PLAN REVIEW NOTES
32 Seapoint Road – M64 L27
Shoreland Development Plan Review

Town of Kittery Maine
Town Planning Board Meeting
July 14, 2016

ITEM 3 – 32 Seapoint Rd – Shoreland Development Plan Review

SHORELAND DEVELOPMENT PLAN

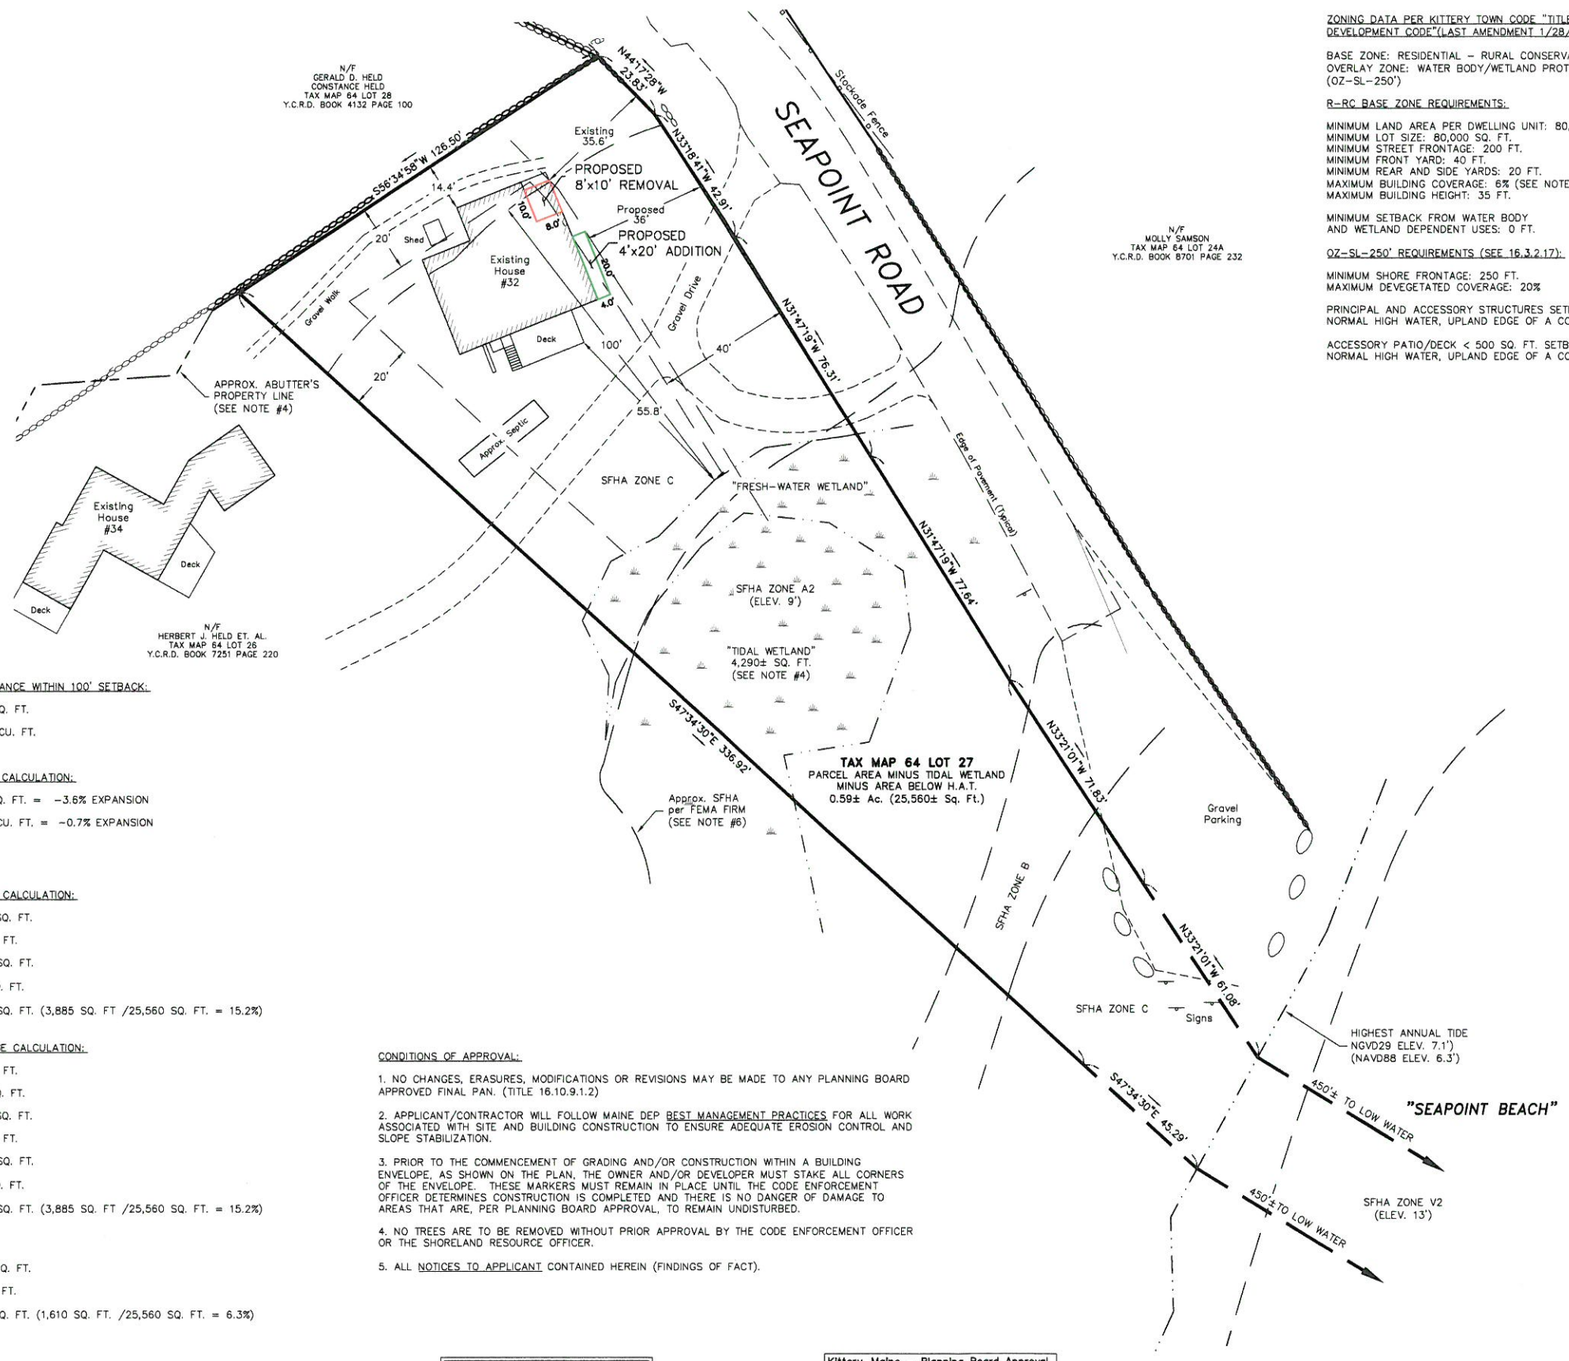
1. Revise floor area and volume calculation table to include the dimensions prior to 1989, what was approved by the Planning Board 1/14/2016 and what is proposed so that a total expansion in floor area and volume since 1/1/1989 is evident.
2. Provide and submit diagrams that support floor area and volume calculations.
3. Include the date of approval in the signature block.
4. Add "Amendment #1" to the title block
